Form 3160-5 (June 2015)

1. Type of Well	8. Well Name and No. TRISTE DRAW 25 FED COM 8H						
☑ Oil Well ☐ Gas Well ☐ Oth							
Name of Operator     CIMAREX ENERGY COMPAN	9. API Well No. 30-025-42102-00-X1						
3a. Address 202 S CHEYENNE AVE. SUIT TULSA, OK 74103	TE 1000		Field and Pool or Exploratory Area     TRISTE DRAW-DELAWARE

Cimarex respectfully request a procedure.	approval for a multibowl w	vell head, please see attached	diagram an	nd			
			SEE A'	TTACHED F SITIONS OF	OR APPROVAL

# PECOS DISTRICT CONDITIONS OF APPROVAL

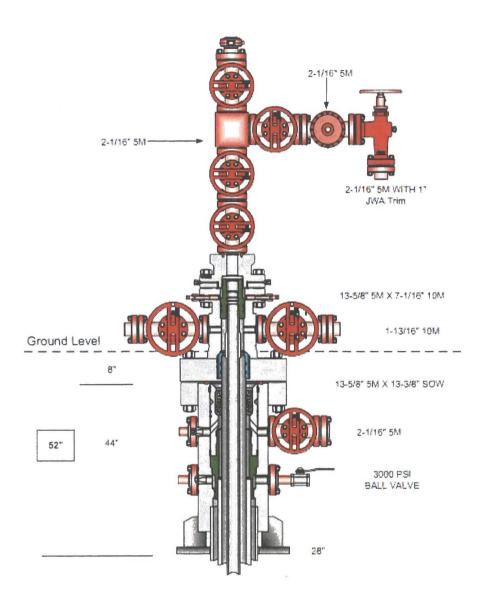
Operator has proposed a multi-bowl wellhead assembly. This assembly will only be tested when installed on the surface casing. Minimum working pressure of the blowout preventer (BOP) and related equipment (BOPE) required for drilling below the intermediate casing shoe shall be 3000 (3M) psi.

- a. Wellhead shall be installed by manufacturer's representatives, submit documentation with subsequent sundry.
- b. If the welding is performed by a third party, the manufacturer's representative shall monitor the temperature to verify that it does not exceed the maximum temperature of the seal.
- c. Manufacturer representative shall install the test plug for the initial BOP test.
- d. If the cement does not circulate and one inch operations would have been possible with a standard wellhead, the well head shall be cut off, cementing operations performed and another wellhead installed.
